Rezoning Application:

MM 26-0553

**Hillsborough
County Florida**

Development Services Department

8.2 Proposed Site Plan (Page 1 of 2)

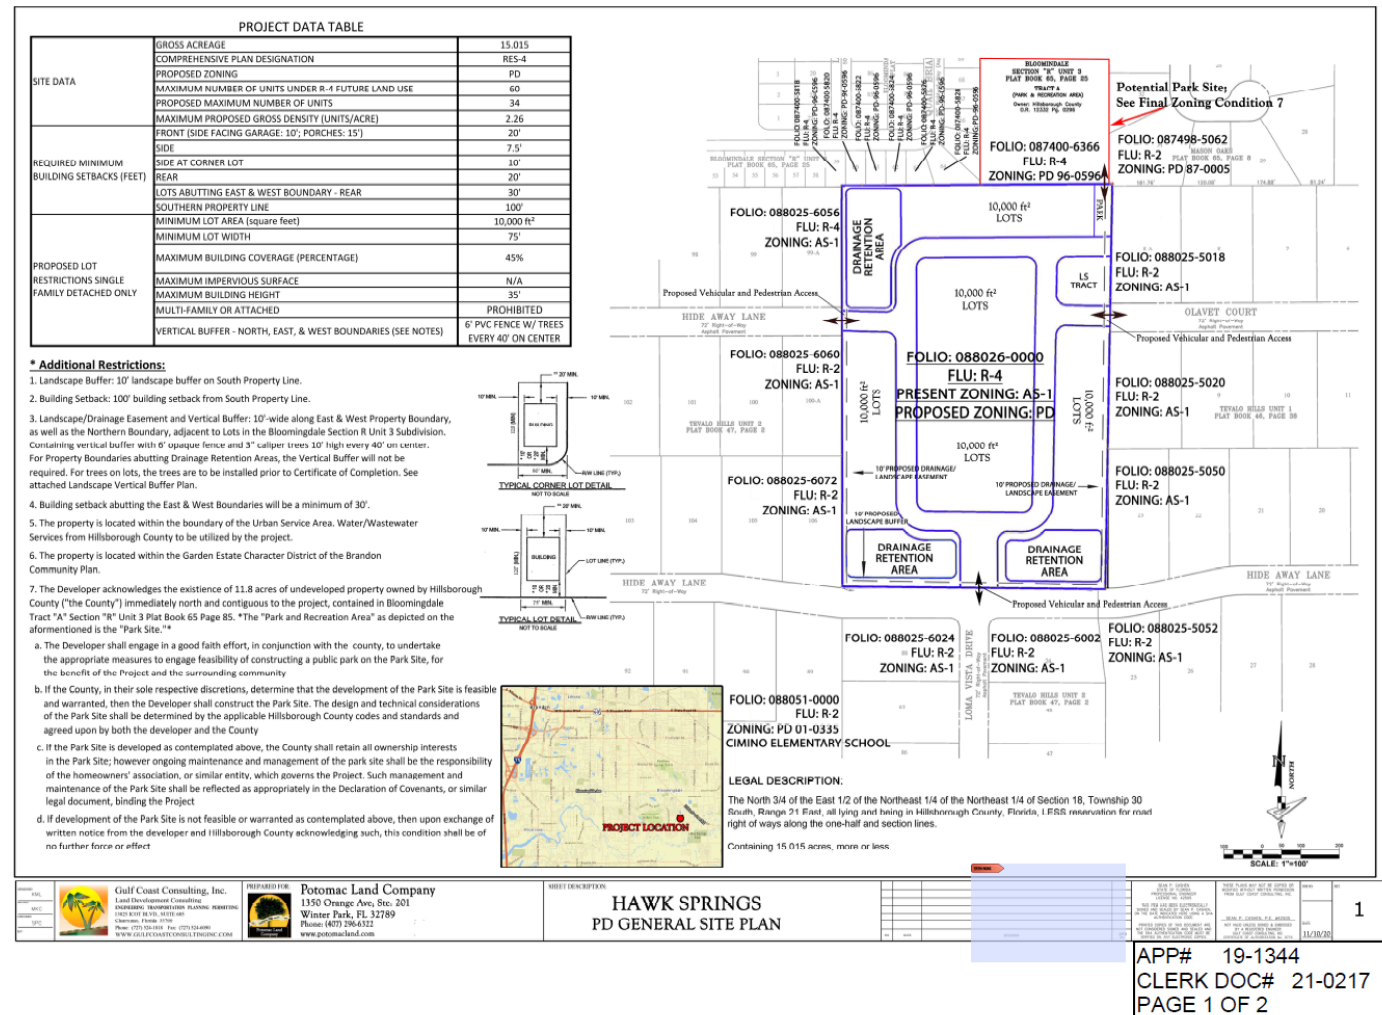
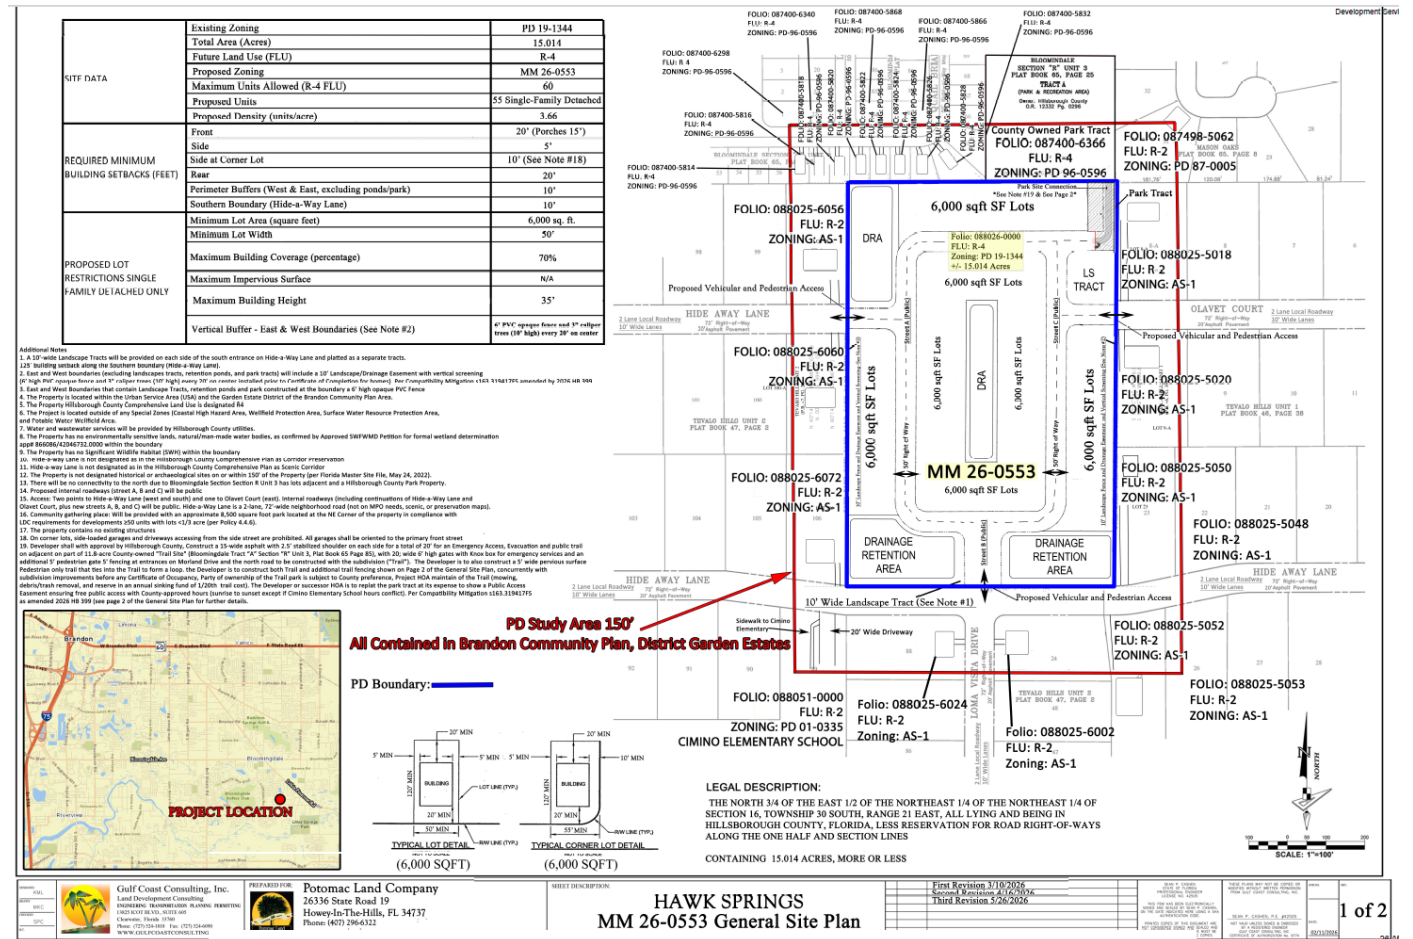
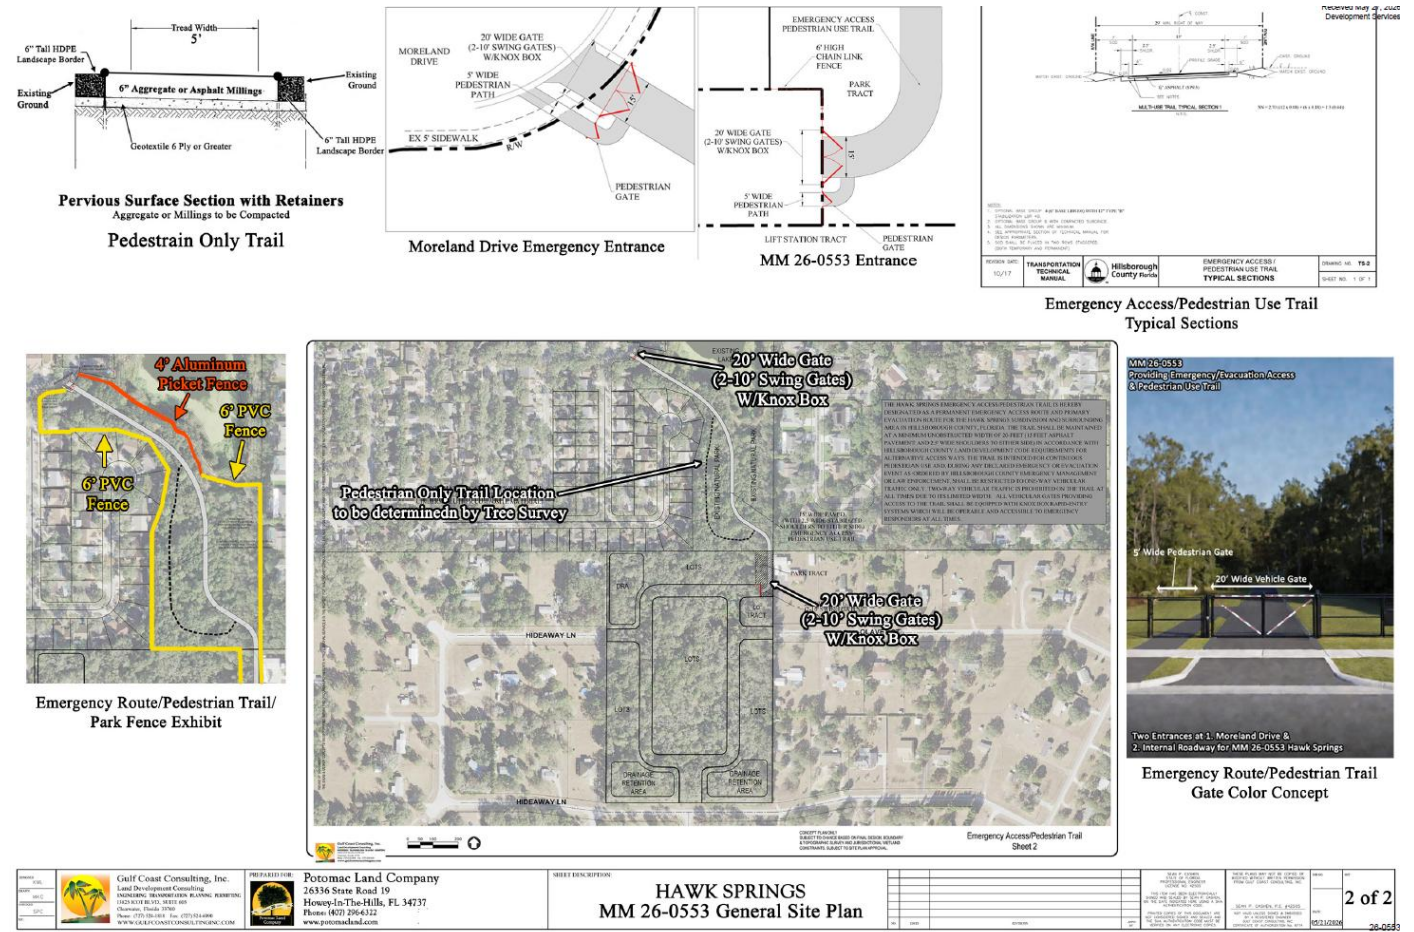
1. The project shall be developed with up to ~~34~~55 single-family conventional detached residential units.

Minimum Lot Size:	10,000 <u>6,000</u> square feet
Minimum Lot Width:	75 <u>50</u> feet
Minimum Front Yard Setback:	20 feet
With Side Facing Garage:	10 feet
With Porches:	15 feet
Minimum Side Yard Setback:	7.5 <u>5</u> feet
Minimum Rear Yard Setback:	20 feet
Minimum Rear Yard Setback:	
For Lots Abutting E&W Boundary:	30 feet
Maximum Building Height:	35 feet
Maximum Building Coverage:	45 <u>70</u> percent

2. A 10-foot landscape buffer shall be located along the southern property boundary.
3. The building setback from the southern property line shall be ~~400~~125 feet.

4. A 10-foot landscape easement shall be located along the east and west property boundaries containing a vertical buffer with a 6-foot opaque PVC fence and 3-inch caliper trees 10'High every ~~40~~20 feet on center.

5. For property boundaries containing drainage retention areas the vertical screen will not be required.
- ~~6. The developer shall construct approximately 3,100 linear feet of sidewalk to connect the subdivision's internal sidewalks to the Lithia Pinecrest Road/Adelaide Avenue Intersection.~~

- ~~76. The Developer shall be allowed three roadway connections. Two connection to Hideway Lane and one connection to Olavet Court.~~
- ~~8. If the zoning is approved, a Design Exception will be approved allowing that in lieu of the developer improving the roadways adjacent to the proposed development (Hideaway Lane, Tevalo Drive and Adelaide Avenue) the developer will be allowed to build approximately 3,100 linear feet of sidewalk to connect the subdivision's internal sidewalks to the Lithia Pinecrest Road/Adelaide Avenue Intersection.~~

97. The planting of required trees shall be sensitive to overhead electric utility lines. Trees that exceed a mature, overall height of 20 feet shall not be planted within 30 feet of an existing or proposed overhead electric utility line.

- 7.1 The developer shall construct a southbound to westbound right turn lane at the intersection of Lithia Pinecrest Rd. and Adelaide Ave. with the initial increment of development.

- 7.2 If PD 26-0553 is approved, the County Engineer will approve a Design Exception (dated June 16, 2026) which was found approvable by the County Engineer (on June 16, 2026) for the existing northbound to westbound left turn lane on Lithia Pinecrest Rd. As the existing urn lane does not comply with the minimum required turn lane length, the Design Exception will allow the turn lane to remain as is.

- 7.3 If PD 26-0553 is approved, the County Engineer will approve a Design Exception (dated June 15, 2026) which was found approvable by the County Engineer (on June 16, 2026) for improvements to Olavet Ct. and Hideaway Ln. As Olavet Ct. and Hideaway Ln. are substandard local roadways, the developer shall make certain improvements consistent with the Design Exception, including constructing a +/-140 feet of 5-foot wide sidewalk and a crosswalk to connect the site to the existing sidewalk within Cimino Elementary School.

- 7.4 Notwithstanding anything shown in the PD site plan or in the PD conditions to the contrary, pedestrian access shall be allowed anywhere along the project boundary.

- 7.5 Construction access shall be limited to those locations shown on the PD site plan which are also proposed vehicular access connections. No construction access shall be taken from Moreland Dr. The developer shall include a note in each site/construction plan submittal which indicates same.

Hawk Springs
Aerial Photo--Offsite Sidewalk

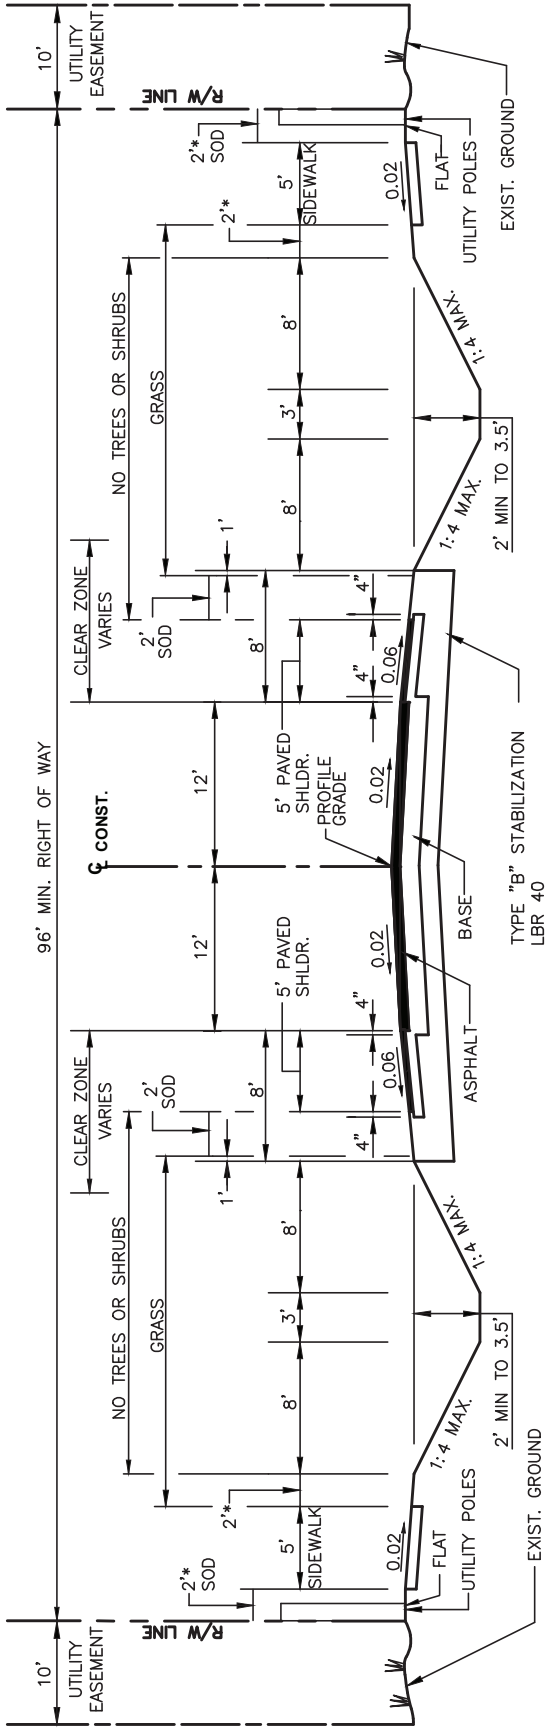
1. *EXISTING CONDITIONS* - As the attached photographs and summary table show, the subject roadways (Hideaway Lane, Tevalo Drive, Olavet Court and Adelaide Avenue) are all a minimum of 20 feet wide, with 10-foot wide travel lanes, approx. 4' wide grassed shoulders with no sidewalk on either sides of these roadways (See Table I on page 2 for TS-7 Requirements and Observed Conditions). This would appear adequate and appropriate given the rural and residential nature of the area.

Elementary School. This sidewalk extension will provide a safe and continuous pedestrian access route from the project site to this school.

Design Element	TS-7 Requirement	Observed and Proposed Conditions
Sidewalk	5 feet on both sides	Current adjacent roads have no sidewalk. Offsite Sidewalk to be provided by developer from site on north side of Olavet Ct. routed east to Tevalo Drive, then west side of Tevalo Drive routed north to north side of Adelaide Ave, routed east to Lithia Pinecrest Road
Swale and clear zone and depth of swale	27 feet total each side consisting of 8' shoulder and 19' wide swale; 2 feet swale depth	Variable along the length of all roads. There is not sufficient right-of-way to provide the full required 27 feet (at 2' depth) adjacent to the segments of Hideaway Lane, Tevalo Drive, Olavet Court and Adelaide Avenue.
Shoulder widths	8 feet (5' paved)	Approx. 4' grassed shoulder
Right-of-Way widths	96 feet	Approx 72 feet
Lane widths	12 feet	Approx. 10 feet

- If PD 26-0553 is approved, the County Engineer will approve a Design Exception (dated June 15, 2026) which was found approvable by the County Engineer (on June 16, 2026) for improvements to Olavet Ct. and Hideaway Ln. As Olavet Ct. and Hideaway Ln. are substandard local roadways, the developer shall make certain improvements consistent with the Design Exception, including constructing a +/-140 feet of 5-foot-wide sidewalk and a crosswalk to connect the site to the existing sidewalk within Cimino Elementary School.
